WOODMEN HILLS METROPOLITAN DISTRICT  
LIFT STATION #1 REPLACEMENT  
GRADING & EROSION CONTROL NOTES

100% DESIGN  
DRAWINGS

PCD File No. PPR1841

WOODMEN HILLS METROPOLITAN DISTRICT  
LIFT STATION #1 REPLACEMENT  
GRADING & EROSION CONTROL PLAN

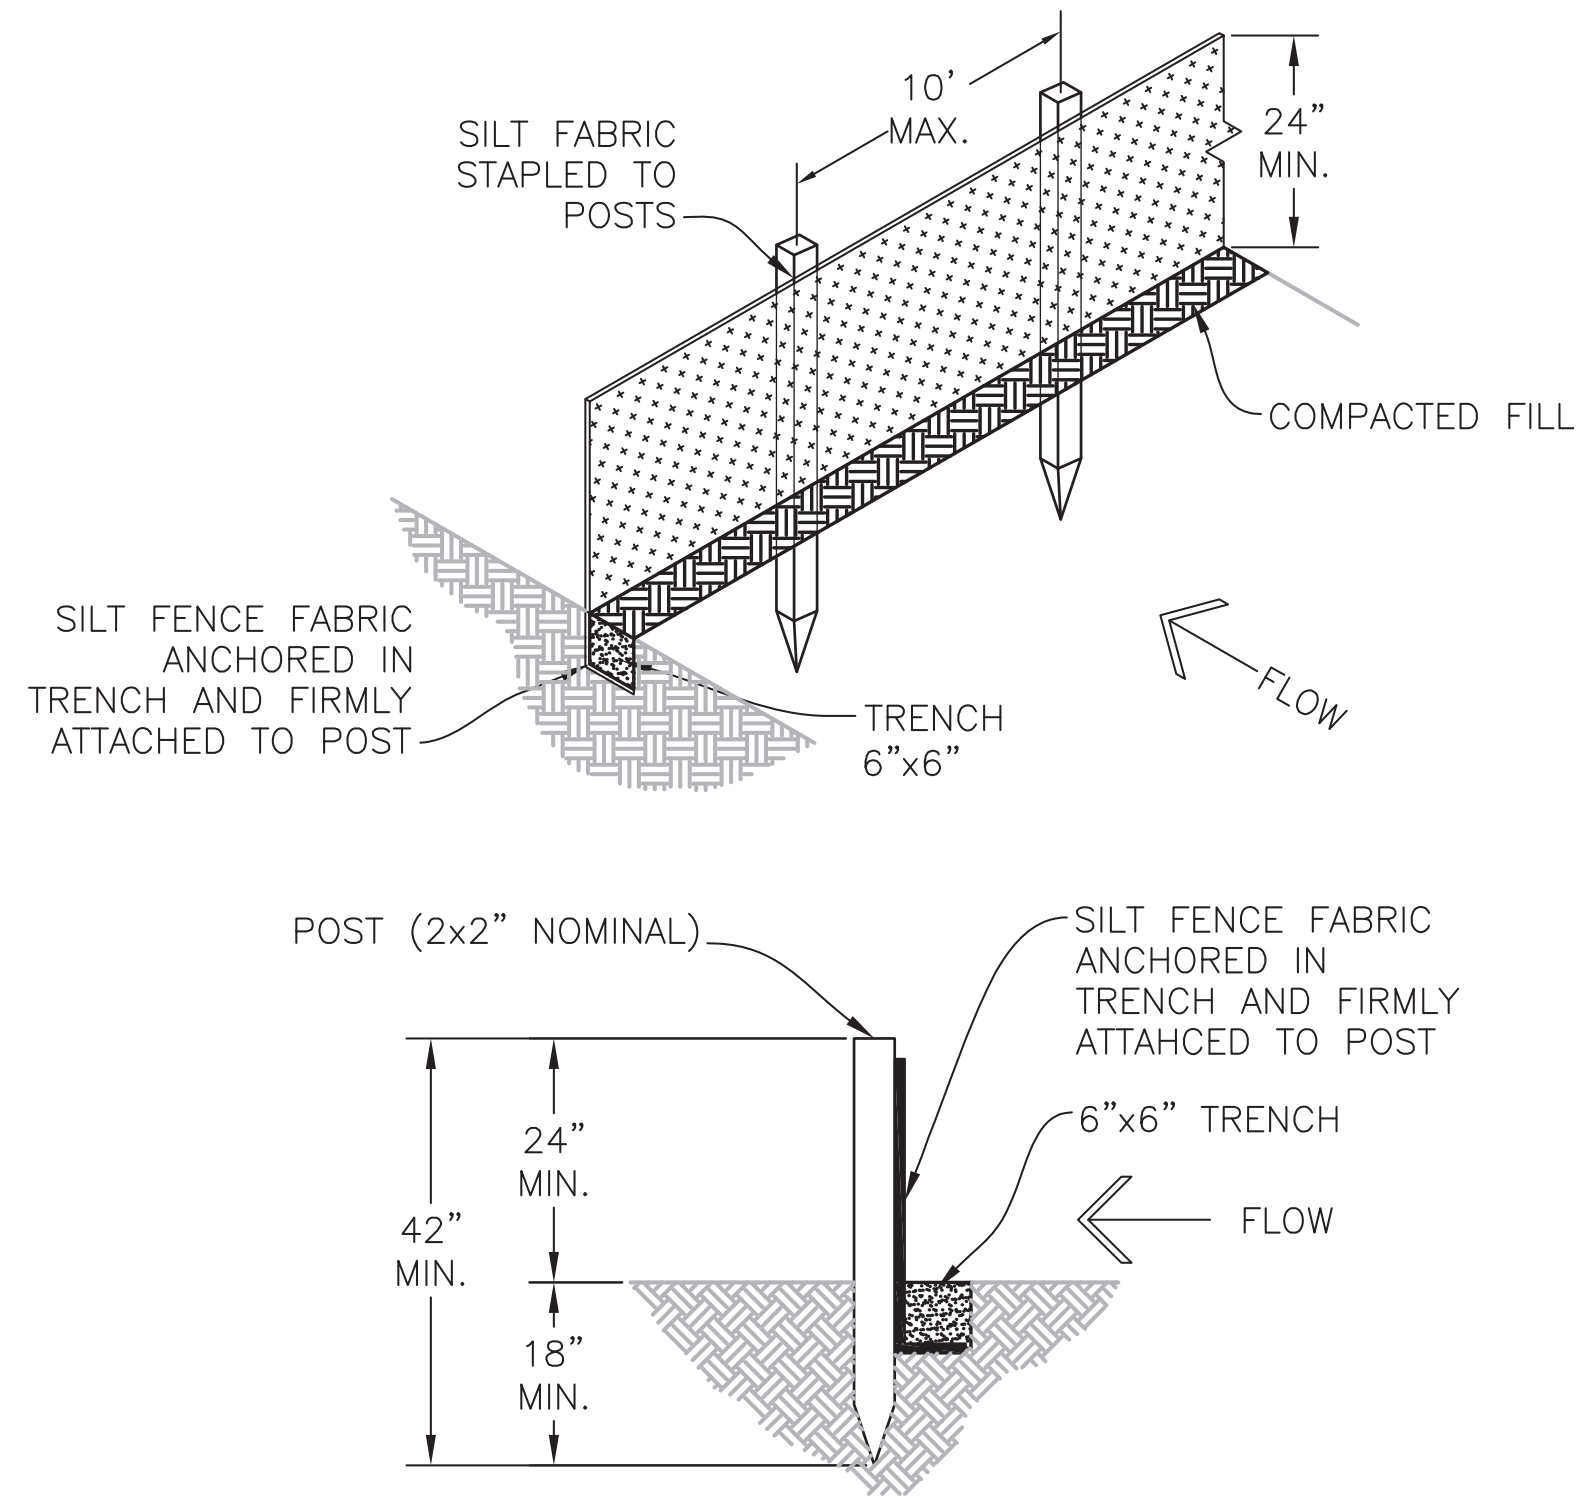
Label or include the hatching in the legend.
